Answer for Major comments:

Answer for Minor comments

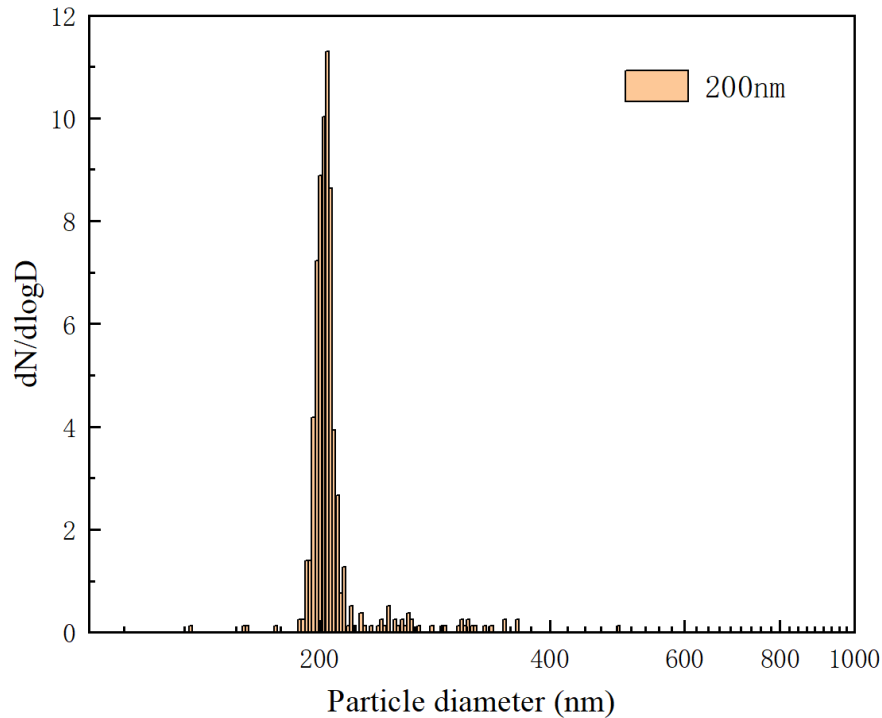
Q1: There are multiple lines of evidence that put the experimental TE results of Fig 7, and the uncanny agreement with simulation, into question. A) Most of the values are exactly 100%, which is highly suspect, and include no error bars showing variability. B) As written, the reference system for submicron sizes (a CPC without a DMA) is incapable of accurately counting PSL generated by nebulization, assuming that many (typically very many) non-PSL (surfactant) particles are also generated. C) The simulated particle trajectories in Fig 6 show that particle beam widths at the detection laser(s) are much larger than a typical SPAMS laser beam width (Du et al., 2024). Therefore a large fraction of the simulated particles would not be detected by SPAMS, and experimental TEs cannot be at or near 100%. Furthermore, it is very likely that these simulated beam widths provide a lower limit, and the actual particle beam widths are probably much larger.

A1: We thank the reviewer for the careful examination of the paper. For issues (a) and (b), the authors performed experimental tests on the transmission efficiency of PSL spheres using SMPS. The figure below shows the particle size distribution when generating 200 nm particle, indicating that the produced particles are primarily 200 nm, with no smaller particles generated. The calculation of transmission efficiency has been defined in Section 2.3, and specific test results are shown in Fig. 6, with error bars added based on the experimental results. Regarding issue (c), the authors would like to clarify that the Bio-SPAMS used in this study is not the same as Du et al.'s HP-SPAMS, and a different laser is employed. This study utilized the Sony SLD3234VF laser, which has a beam width of 3 mm, larger than the beam width shown in Fig. 6, thus it will not affect particle counting.
